## **Make I-45 Better Coalition: Summary of Resident Comments (Source: NHHIP Interactive Map)**

The document below is a review of the comments from the NHHIP website's interactive map (<http://www.houstontx.gov/planning/nhhip/>) as of 9/15/19. The top portion of this document summarizes those comments generally and by segment. Continuing further down the document you can view most (impossible to guarantee that none were missed as there are many) of the comments as of 9/15/19, grouped into more localized sections of the map, not the three segments as generally defined. The presentation below shows a map followed by the comments from that map section.

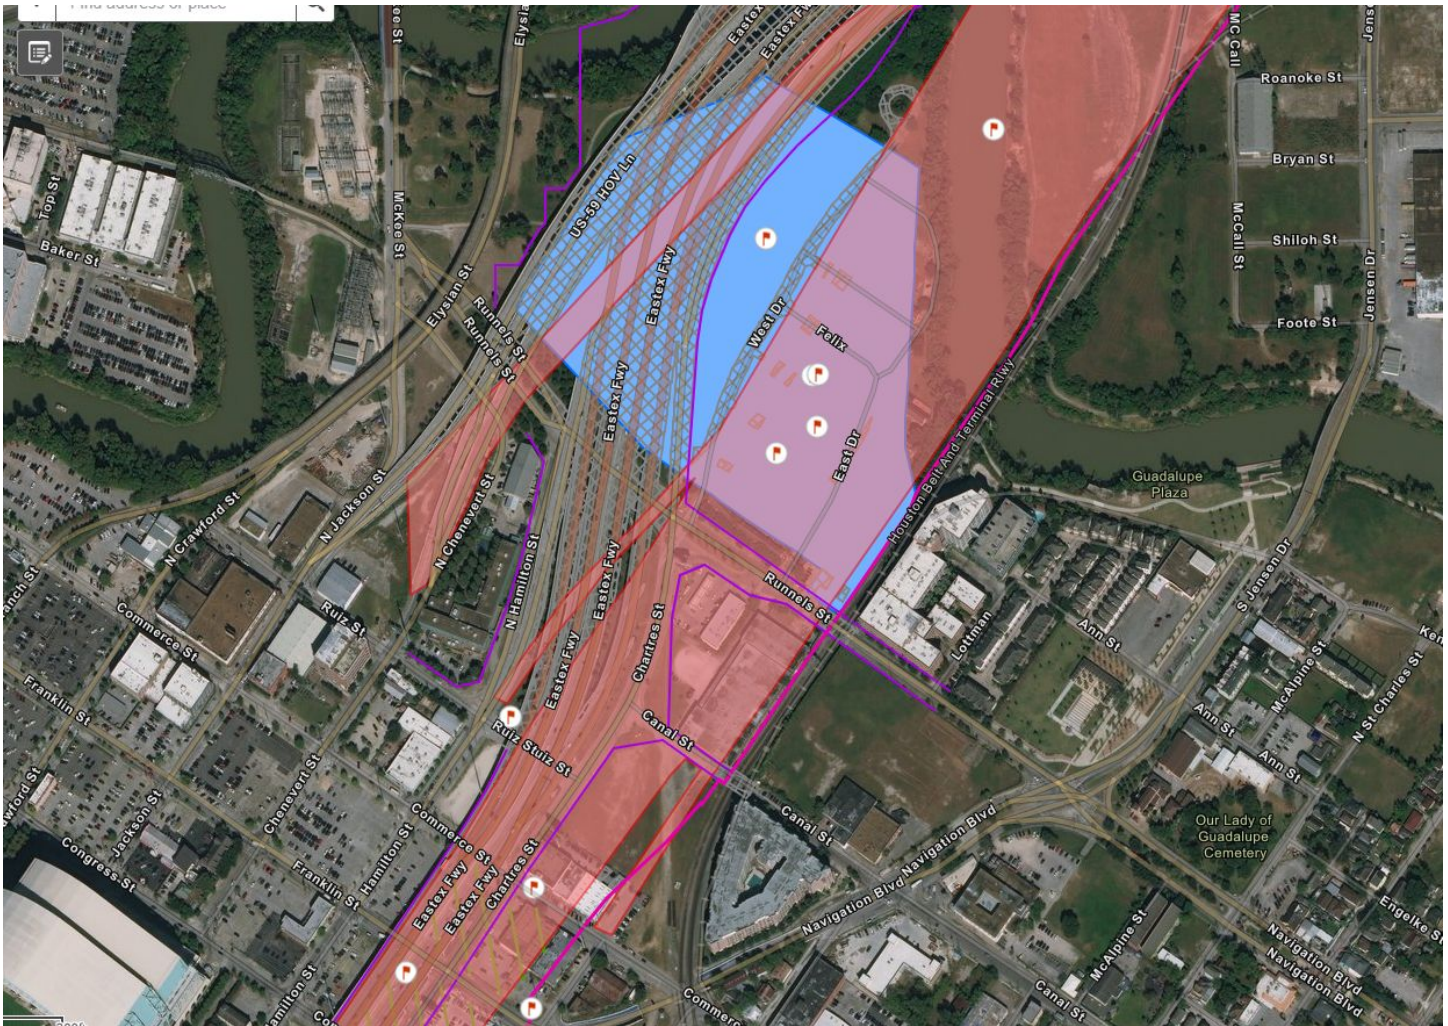
- Segment 3: 59 and Louisiana exit: put up pylons, ctb, and a water barells to separate the 2 exit lanes from the continuing. Every one parks at the end of the exit in the painted area trying to get into the continuation lane to skip over traffic. It's unsafe for everyone. **Safety Concern**.

- Segment 3: Why is TxDOT planning to narrow HOV lane to 22' from existing 35'? Should be designed to allow 2-way HOV! **Traffic Concern**
- Segment 3: I-69 at Spur 527: The left lane exit from I-69 north to Spur 527 is a 1950s era design relic. Since this stretch is now an Interstate, the exit to Spur 527 should be moved to the right side. It would eliminate weaving and backups caused by the weaving in that section. **Design Safety Concern**

- General: Rosedale and Louisiana: We already have traffic problems enough on these back streets with the proliferation of high rises all around us. How much MORE traffic is Rosedale going to see and will we be able to reroute it? **Traffic**

- Segment 3: Wentworth @ Main: if this ramp is being rebuilt, please rebuild it as a normal urban intersection with a light and no right turn slip lane. Lots of people walk along Main and that number is only going to increase. **Safety for pedestrians**

- Segment 3: Visual Impacts: I understand that the Spur isn't part of the scope, but this should be reconsidered. We are submerging all of 59, its awkward to keep the spur above ground at this point. One of the goals is to restitch areas together. A great moment to do so here too. **Visual**

- Segment 3: Alameda south of 59: Remove right turn slip lane **Safety**
- Segment 3: Visual impacts: Cap parks idea only and not in the FEIS **Visual**

- Segment 3: Alameda at Cleburne: Wasn't there an iteration where Cleburne could be extended over the freeway through a cap park? With the upcoming housing to the east on Cleburne, it seems prudent to keep it as an east/west connector. **Traffic design**
- Segment 3: Displacement, when will the Sale happen? **displacement**
- Segment 3: Wheeler/288: Add noise barrier to top of main lanes ...**Traffic Design**
- Segment 3: Chenevert at Francis: Please restore the street grid here. **Safety**
- Segment 3: Chenevert at Francis: Downtown has all the funding everyone else doesn't. They get all the nice things. We DON'T #TXNOT . **Walk/bike/transit/parks**
- Segment 3: Elgin east of 288: Remove right turn slip lane; unsafe and unpleasant for pedestrians and cyclists **Safety**
- Segment 3: 288/Elgin: Add noise/landscape barriers to protect the community **Design/Noise**

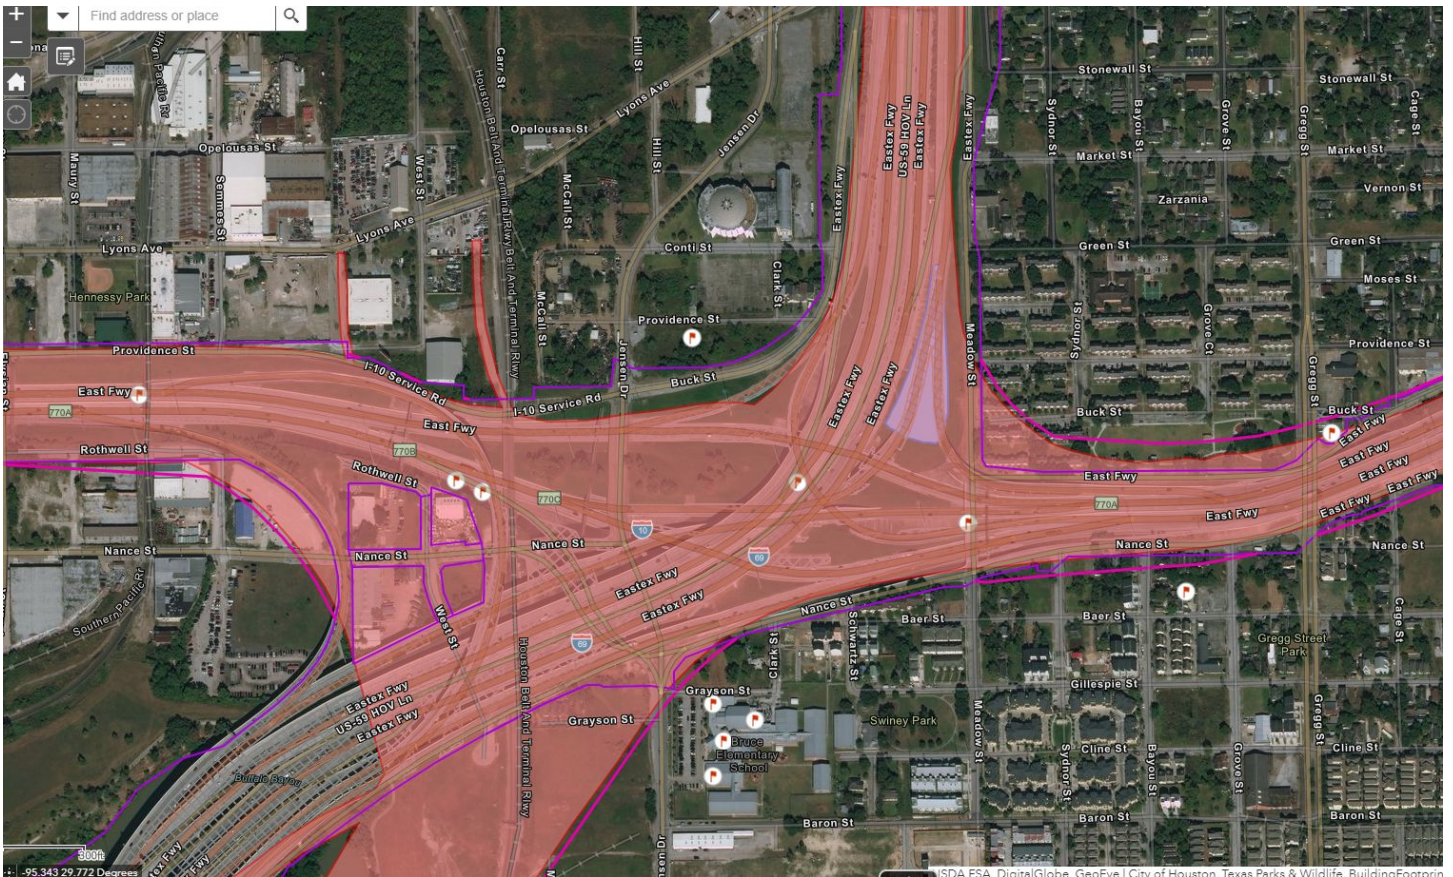
- Segment 3: Elgin at NHHIP: cap this submerged part of the freeway. The 3rd Ward has long been divided by the freeway; a cap here would serve to reconnect neighborhoods. **Design**

- Segment 3: McGowen/Chartres - when will we get an offer for the lot at McGowen/Chartres **Displacement**
- Segment 3: Webster at St. Emanuel: Severing this connection will make access unnessecarilly difficult and inconvenient. **Inconvenience (connectivity)**

- Segment 3: Proposed I-45 curve: How will having such a curve on I-45 impact traffic flow? Will the elevation change and combined curve slow down traffic even more? **Design concern**

- Segment 3: Pierce Elevated: The Pierce is an important local connection between eastern/southeastern neighborhoods and western neighborhood. Keep the Pierce Elevated -- or consider submerging it through here.

- General: Pierce Elevated: The Pierce Elevated should stay in its current alignment. Moving it only benefits Midtown. Even with cap parks on the new alignment, you're going to have two freeways separating the East End and Near Northside from Downtown. Robbing Peter to pay Paul? **Design**

- Segment 3: Pierce Elevated: Double deck Pierce Elevated
- Segment 3: Jefferson at Heiner: Pedestrian sidewalk connection here please. **pedestrians**
- Segment 3: Charters Corridor: TxDOT estimates for loss of tax revenue for this project do not capture the lost opportunity cost of redeveloping the parcels that are directly next to Downtown and could otherwise be redeveloped into higher value properties. **Displacement/Economic Cost.**

- Segment 3: 59NB to 45NB: currently, 2 lanes of traffic from 59NB to 45NB are not sufficient, one lane will certainly not be sufficient. **Shrinking capacity?**

- Segment 3: Leeland @ NHHIP: TxDOT needs to determine how WB traffic on Leeland will have a seamless entrance into downtown. **Traffic Concern/freeway exit concern**

- Segment 3: Leeland to Bell: Access from Leeland to Bell is a vital connection from the east end to downtown. **Freeway access concern**
- General: I honestly believe that this new expansion is a detriment to the city as this new expansion will take at least a decade to complete and by then the city's needs would have changed leading to a colossal waste of taxpayer money and time. **Whole thing is a disaster**

- Segment 3: Polk: Closing Polk is incredibly dumb...there will be no strong east west connections between the East End and Downtown from IH 45 to IH 10 which is almost 2 miles **Traffic**

- Segment 3: Polk@ I-45: Polk U-turn is dangerous ... same spot wants bike/ped connectivity.**Design**
- Segment 3: Polk at NHHIP: Polk needs to connect across NHHIP. It is more important than the cap park. Additionally, the proposed WB Polk U-turn will be dangerous, because vehicles will have to negotiate with cars coming off the off-ramp from NHHIP.

- Segment 3: Lamar: The exit from 59 NB to the downtown area is too close to the uturn lane for people trying to cross the freeway to access downtown destinations from the east side of houston via the uturn that is there for polk

- Segment 3 : U Turn: The design of this Uturn and the force merge of the traffic on Hamilton with both the Uturn traffic and the left turn traffic from

- Segment 3: General: How long will this impact tourism and sports venues?
- Segment 3: What are the plans to enhance connectivity and pedestrian safety from the columbia tap rail to the cap park? i.e., emancipation and St. emmanuel intersections are barriers for pedestrian safety and access to the proposed cap park **Pedestrian safety**

- Segment 3: St Emanuel north of Ranklin: Why realign the street grid here? Would it be possible to keep some of these buildings if the street weren't swerved to the side like this?
- Segment 3: Franklin: The proposed design of the Navigation Underpass connecting to the new freeway road seems very unsafe as people come up from under the track into new road much closer than current Chartres

- Segment 3: Franklin: The proposed design of the Navigation Underpass connecting to the new freeway road seems very unsafe as people come up from under the track into new road much closer than current Chartres **Safety**.

- Segment 3: Franklin off ramps: Having two parallel freeway off-ramps with traffic in same direction will create significant traffic congestion and confusion especially when introduced into an alternating one way grid. **Traffic!**

- General: hundreds of people live here..
- General: Are these ponds sufficient to detain not only the increased detention demand from the expansion but account for previously unaccounted development as well as stormwater quality. Will this provide park amenities for citizens?

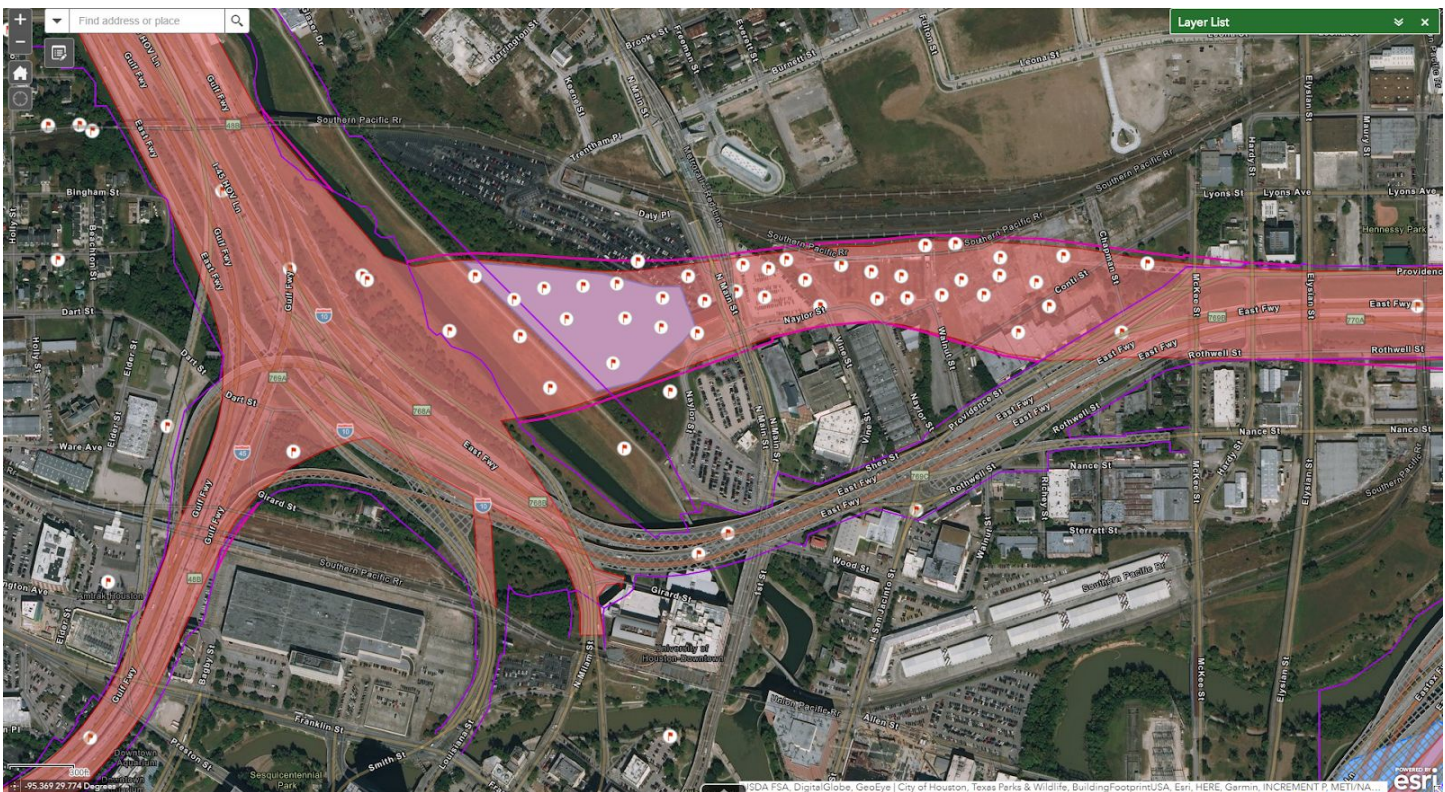
- Segment 3: Jensen exit from i10: the former KBR site is being rebuilt as the East River Project. Jensen exit is the best access for what is the largest project near downtown. the best access to this is being moved farther away. **Displacement...convenience impact**

- Segment 3: Jensen Exit form i10: the new exit from i10 to access Jensen is a few hundred feet from the i45 exit to i10. people who are trying to exit Jensen from 45 are going to cut across 4 lanes of traffic to access the exit for Jensen this will slow down traffic and be very unsafe **convenience**

- Segment 3: Bruce elementary: This is an elementary school campus that will literally be in the shadow of the freeway expansion. The implications to health and safety and an environment condicive to learningshould be obvious to anybody that has given any thought to the impact of this **Safety**

- Segment 3: Bruce Elementary: Save the kids **Safety**
- Segment 3: 510 Jensen Dr, Houston, TX 77020: There are many young children that walk to school in groups. Also there are 3 bus stops in very close proximity that have ridership. Its not only important to make this area more walkable but also their safety, especially as people exit the highway **Safety**

- Segment 3: Because of the freeway, air quality will be so bad that children shouldn't play outside. TxDOT must purchase a new Bruce Elementary campus at a safe distance from the freeway.

- Segment 3: Displacement in General: Relocation counselling and assistance should include cost of utilities, application costs, security deposit, in addition to moving costs for **RENTERS**.  
**cost/displacement**
- Segment 3: Meadow Street: This is the pedestrian route taken by many Bruce Elementary students to get to/from school. Make it safer, not more entwined with the freeway . **safety**
- Segent 3: 3405 Nance St, Houston, TX 77020: Goodwill MBC (Church) **displacement**

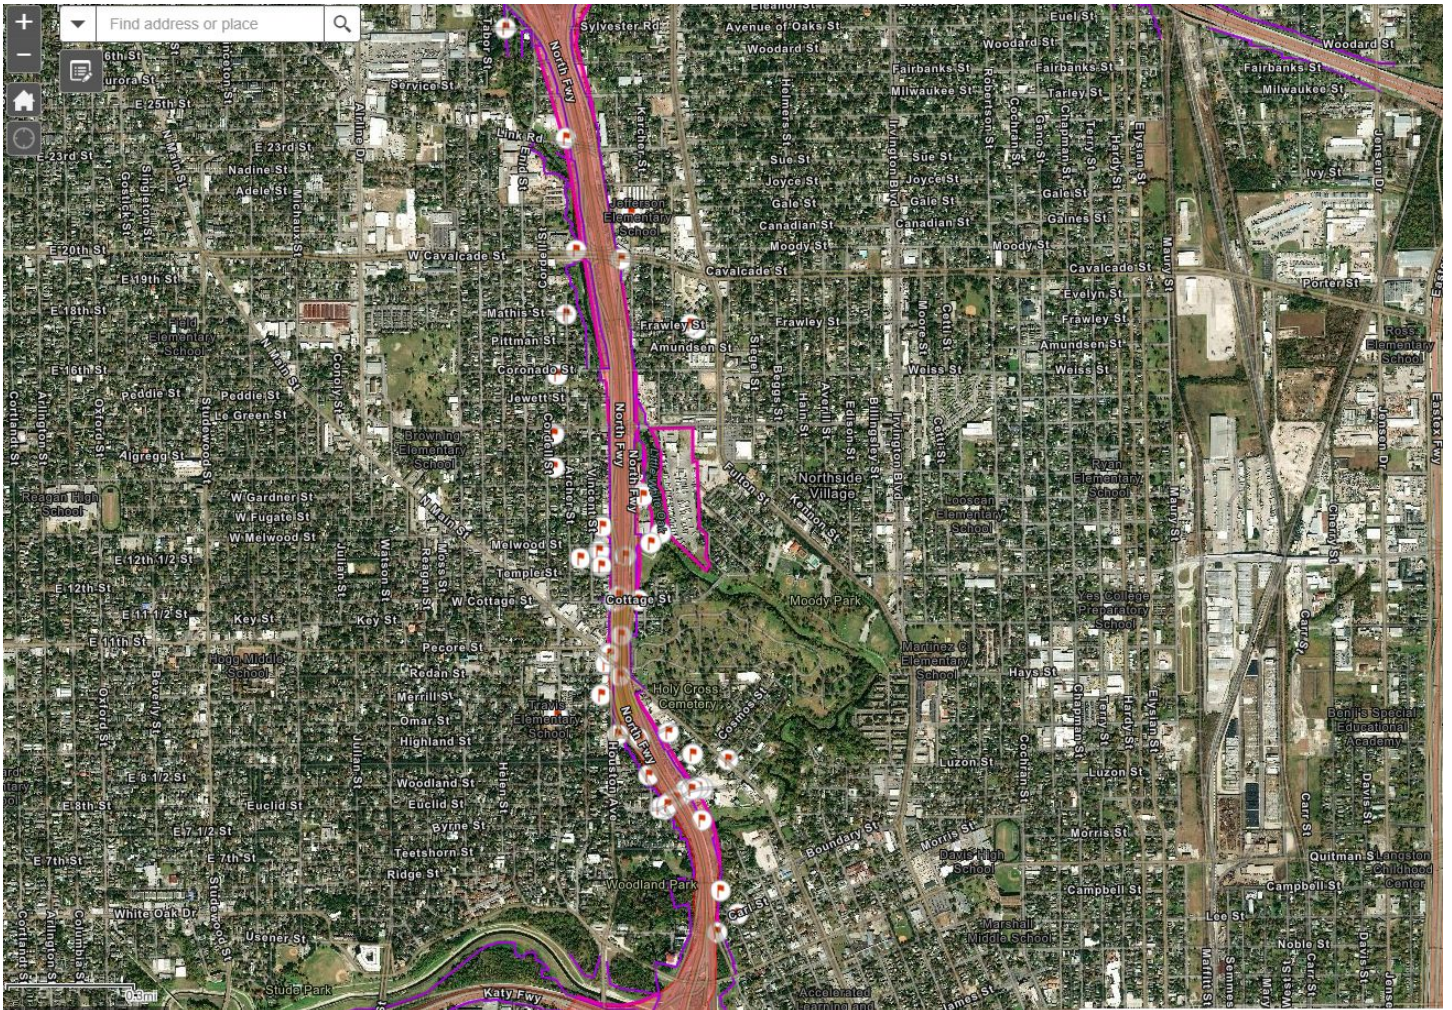
- Segment 3: Please keep this section to the existing right-of-way and do not push it north as proposed. It will do irreparable damage to our neighborhood. Thank you.

- exit from i10 to San Jacinto being removed
- Our entire neighborhood just north of here will feel the pain of this reroute of I-45. Please keep this section in its current right-of-way or tunnel it underground and put a park on top - like the EaDo portion.

- Please utilize the existing right of way to the south instead of moving this section to the north. A new above-ground freeway will even further cut off the Near Northside from downtown and create a racial, class, and economic barrier between them.

- Please just make this entire portion go away. It will be a terrible eyesore and destroy our neighborhood.
- If the freeway is to be relocated here, it needs serious soundproofing and pollution mitigation such as barriers and lots and lots of plants and trees around the edges

- Has anybody given any thought to the effects on air quality resulting from rerouting all major through traffic in the city through one corridor?
- Please plant layers and layers of trees and plants along the northern edge to entirely block the freeway visually from the neighborhood and provide a protective barrier against some of the harmful pollutants given off by cars.

- Why does the freeway need to move here? It's massively disruptive and will destroy this neighborhood.
- The new towering stacked freeways will be closer, taller, and thus emit more particulate matter and toxins to the residents to the north. Please use the existing right of way and plant forests of trees lining and blocking the freeway from the neighborhood

- Please do not locate this portion of the freeway here. Please utilize the existing right-of-way to the south.
- These historic warehouses will now be overshadowed by the freeway. Please use the existing right-of-way to the south instead of moving this segment north to this section.

- This will greatly impact UH-Downtown and its ability to improve and succeed.
- This entire zone from White Oak Bayou to the west to Elysian to the east needs to be reworked. Please find a way to utilize the existing right of way and/or tunnel the freeway here. The visual effects of the freeway as it's proposed will be substantial.

- The immense elevation of freeways on top of elevated rail will create a massive visual blight to residents and businesses just north. Please utilize the existing right-of-way or consider tunneling the freeways here.

- Losing so much green space with this plan. Space under a freeway does not count as "green space" by the way.
- This entire section needs to be sequestered to protect the residences to the north. Harmful air pollution will affect the people there. Please either: wall the freeways and plant thousands of trees and plants to cover the walls; or tunnel entire freeway here

- Parks under freeways are horrible for people's health. The park needs to be ON TOP of the freeway. Please tunnel this portion of I-45/I-10.
- Shameful the freeway is going to so severely impact the bayou park here removing one of our only nearby parks

- We will now have to take our children biking under a massive freeway when we ride along the bayou here. It's disgusting.
- A large part of this park will be covered or destroyed because of the increased right-of-way. Please utilize the existing right-of-way that is on the south side of UH Downtown's new Science and Technology building or find a way to tunnel the freeways here

- Segment 3: IH10 Connector: The removal of the IH10 Transit HOV connector will negatively impact transit on the IH10 corridor and should be maintained or mitigated...forcing buses to mix with managed lanes will slow them down significantly

- Segment 3: I-10 Connector: I don't understand why the original 4-lane Downtown Connector was replaced with a 6-lane connector. Rerouting 45 makes it possible to enhance the beauty of this side of downtown, so why are we building a connector that is as wide as many freeways?

- Segment 3: I-45 Southbound from Crockett St to I-69: At this location, 2 left southbound lanes merge/end. This will cause traffic slowdowns and become an accident hot spot. Please remove this bottleneck by connecting the extra lanes with an extra exit to Smith St and the current planned exit to I-69.

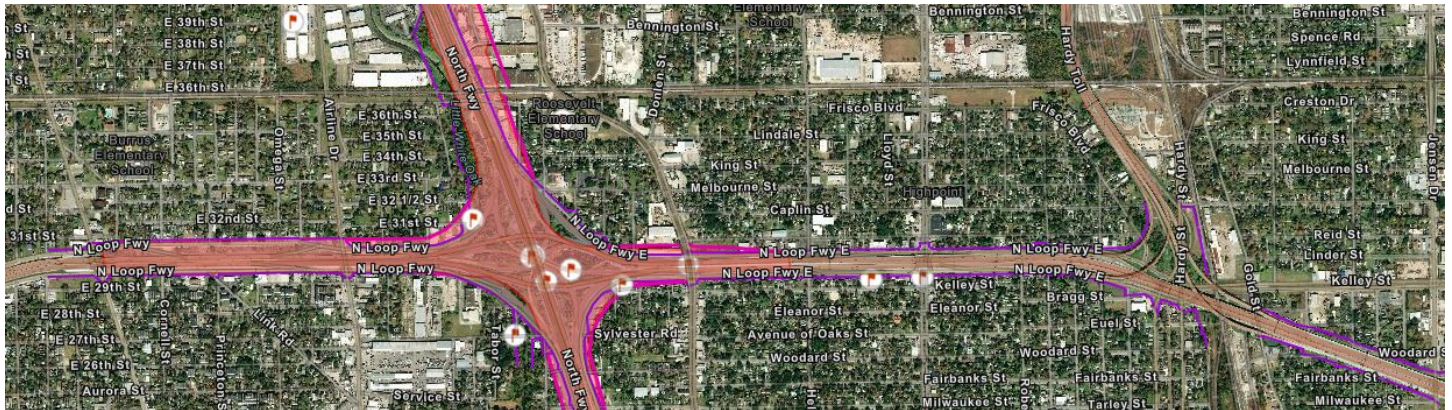
- Segment 2: 45 and Carl” noise air quality.//test/test
- Segment 2: 2404 South St, Houston TX 77009: Safety and connectivity concerns: Charles Ziehn, access to I-10, I-45. 713-237-0698
- Segment 2: Include sound barriers to protect homes from noise. Ideal and Embry home owners.
- Segment 2: Glen Park to Travis Elementary ..safety/conenctivity
- Segment 2: noise air; ...quality. Also need it to be aesthetic walls adjacent and residential.
- Segment 2: My kids are zoned to Travis Elementary. No safe access from Glen Park once North St. Bridge is removed.
- Segment 2: Keep North St Bridge. Needed for connectivity and for evacuation when extreme flooding.

- Segment 2: North Street is a key connection for cyclists and pedestrians. You can close it to cars but it must remain open for vulnerable road users.

- Segment 2: North Street is a valuable connection between Near Northside and Germantown/Woodland Heights. Do not remove that connection.
- Segment 2: Remove pedestrian friendly bridge. North Street Bridge.

- Segment 2: Northside has few connections to abutting neighborhoods and North Street is one of them. Cutting this out isolates the community even further.

- Segment 2: These apartments are the only affordable place to live zoned to Travis Elementary
- Segment 2: Weird half circle south of N Main: This partial circle is weird and a waste of space

- Segment 2: You are dividing neighborhoods.
- Segment 2: Southbound N. Main Exit and I-45: Do not move or eliminate any Southbound exits between 610 and I-10.

- Segment 2: N. Main Exit going South on 1-45: Do not move or eliminate any of the South bound exits between 610 and I-10
- Segment 2: N. Main Exit going South on 1-45: The exit to Main St. must remain open and in it's current location. If any southbound exits from 610 to i-10 are closed, there will

- Segment 2: How to access this cap park?? Submerge frontage lanes or else the "park" will be a gray empty desert.
- Segment 2: Keep Cottage St. Bridge
- Segment 2: (Keep Cottage St. bridge) Yes!! Needed for connectivity

- Segment 2: On ramp to 45 here will keep traffic out of feeder
- Segment 2: We need exit to N Main heading South on I-45
- Segment 2: Need ramp onto N Main from I-45 S. Not all the way at the 610 interchange

- Segment 2: Highways divide communities
- Segment 2: Need ramp onto N Main from I-45 S. Not all the way at the 610 interchange
- Segment 2: Sound barriers and lots of vegetation for entire length, both sides. Not just at intersection

- Segment 2: Need entrance ramp from the major thoroughfare N Main to I-45 N. No access to 610 direct connect.
- Segment 2: (Little White Oak) Make this retention pond area a park like space, work with naturalists to make it workable for native mammals and birds, trails, etc.

- Segment 2: Save the Children! Jefferson Elementary .

- Segment 2: Jefferson Elementary: Mitigation measures? Trees, noise shields, better air filters in the schools?
- Segment 2: Link Rd. Displacement: Water heater installer building must be torn down :(
